MEMORANDUM

Subject: 1-5 Glen Street and 2-8 Lakeside Road, Eastwood
LDA 2015/666. JRPP No 2016/SYE028

SUPPLEMENTARY REPORT

1-5 Glen Street and 2-8 Lakeside Road, Eastwood. Lots 3 to 9 in DP 8043 Local Development Application for Demolition of existing structures, amalgamation of the seven sites and construction of a 4 storey mixed use development with 2 levels of basement parking, ground floor retail tenancies and 3 residential levels comprising of 74 units. JRPP No. 2016/SYE028. LDA 2016/666.

DRAWING			
GENERAL NORTH ELEVATION		REVISION	
PROJECT NO.	DRAWING NO.	B	
15-017	DA-400		
SCALE @ A3	DATE	DRAWN	AUTHORISED
1 : 300	13/02/2015	DA	FC

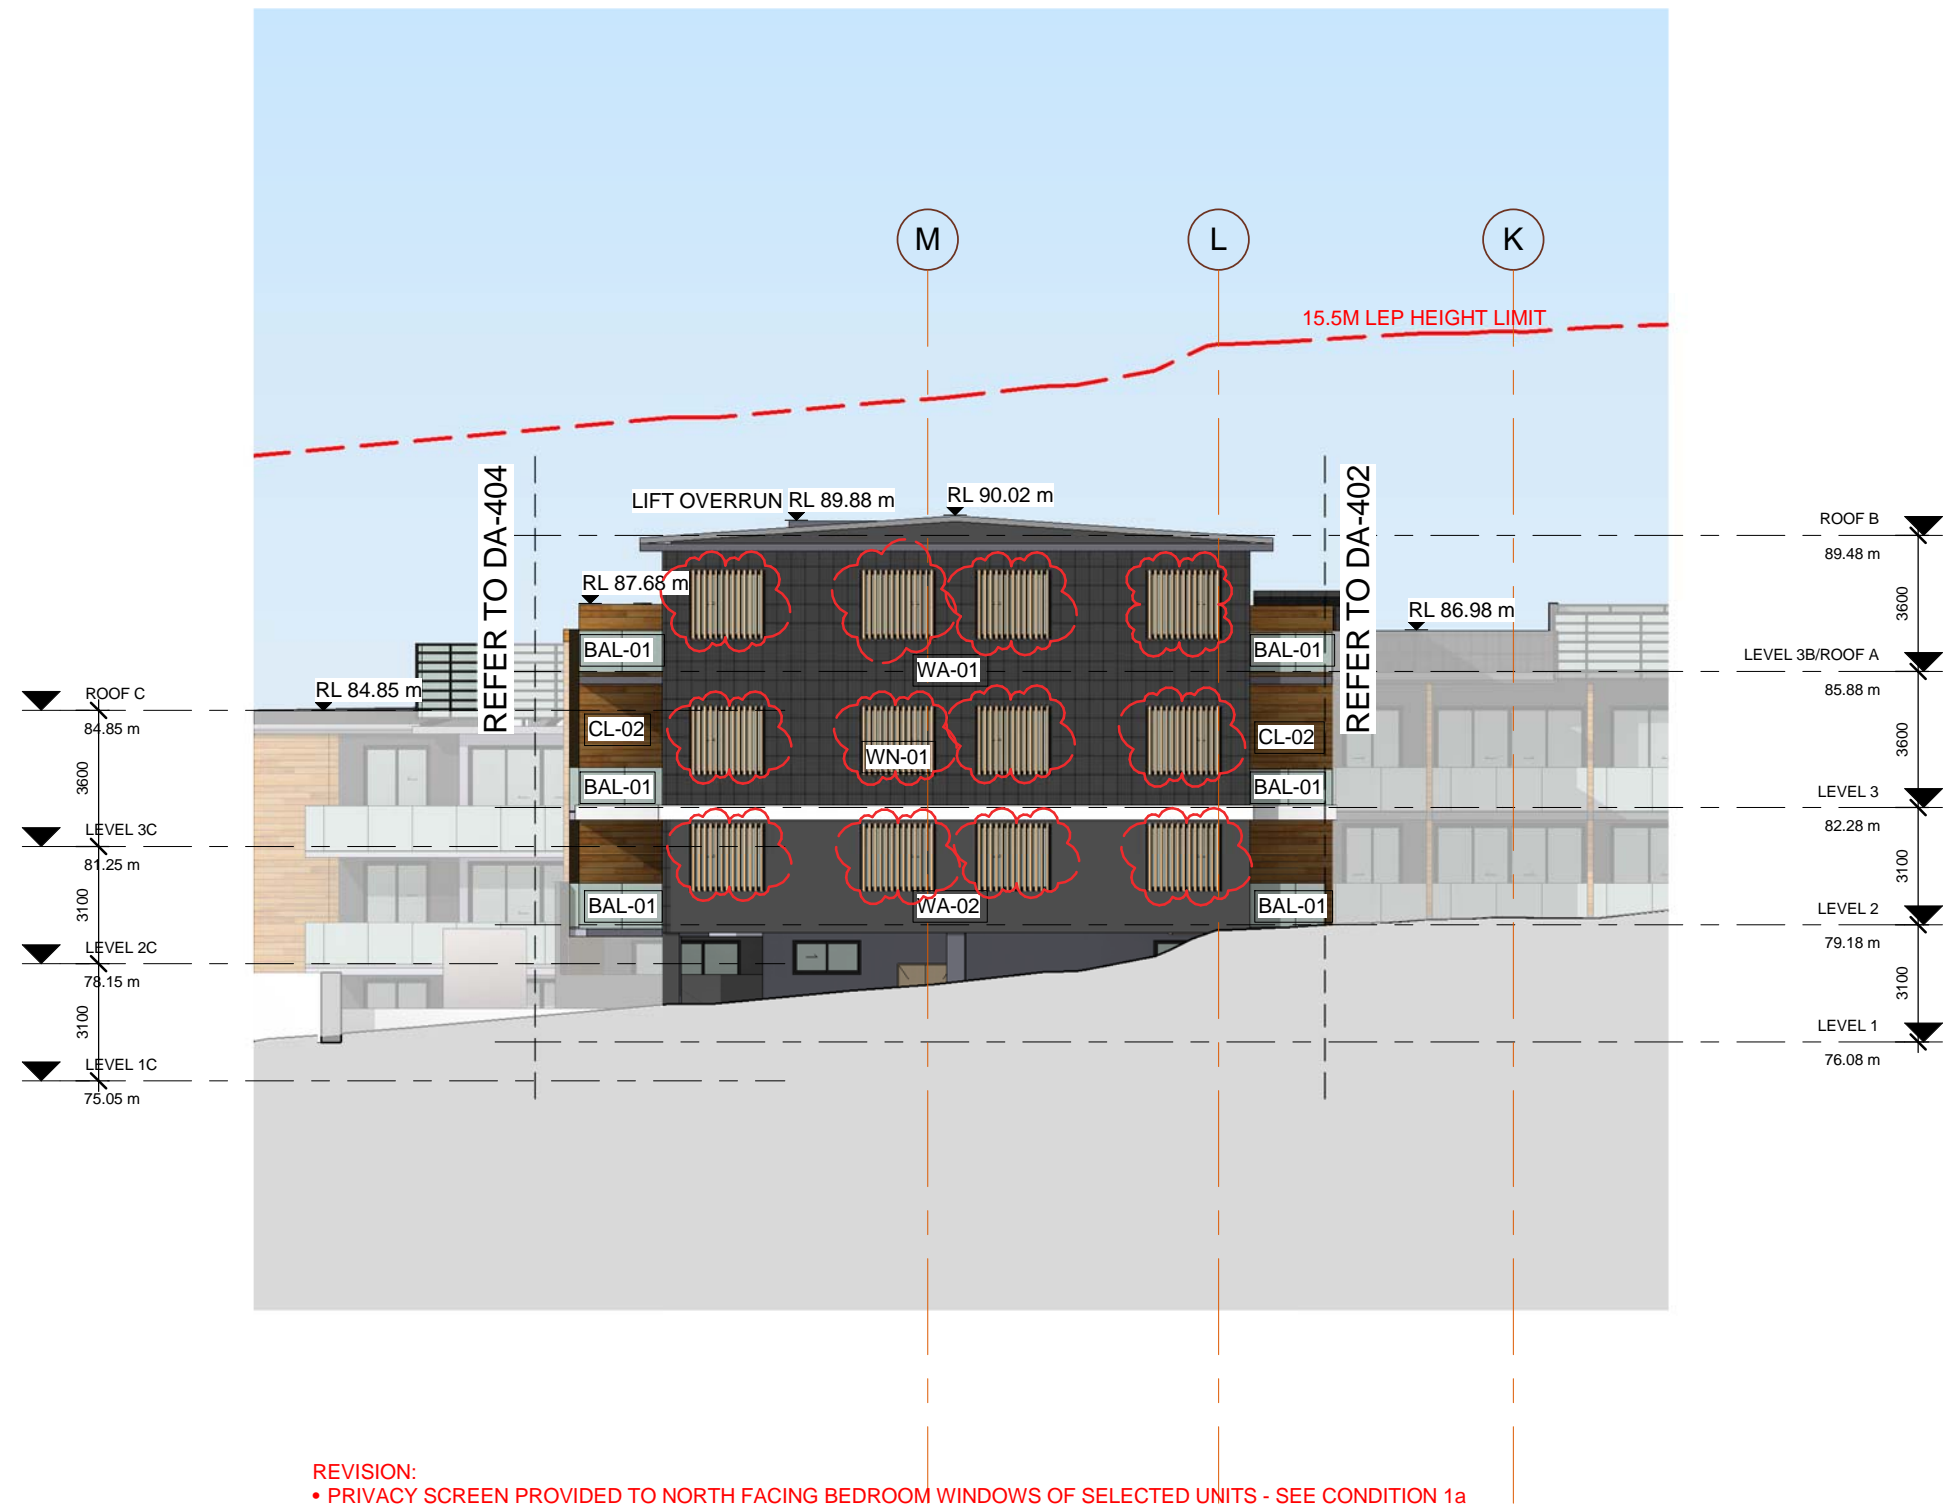
The panel also noted concerns about privacy and overlooking to the school adjoining the rear of the site. To address these concerns, the panel recommended that privacy treatment to the bedroom windows on Units B2.04, B2.05, B3.04, B3.05, B3B.04 and B3B.05 be provided.

The panel raised concerns about privacy and overlooking from the bedroom windows of B2.04, B2.05, B3.04, B3.05, B3B.04 and B3B.05 which faces the school adjoining the rear of the site (north facing). To address this concern the panel noted that a condition should be imposed to provide privacy treatment to the above units which have their bedroom windows facing the school.

The applicant has submitted amended plans which show a privacy screen to each of the north facing bedroom windows of the above units. Condition 1 of the draft conditions has been amended to reflect the amended plans.
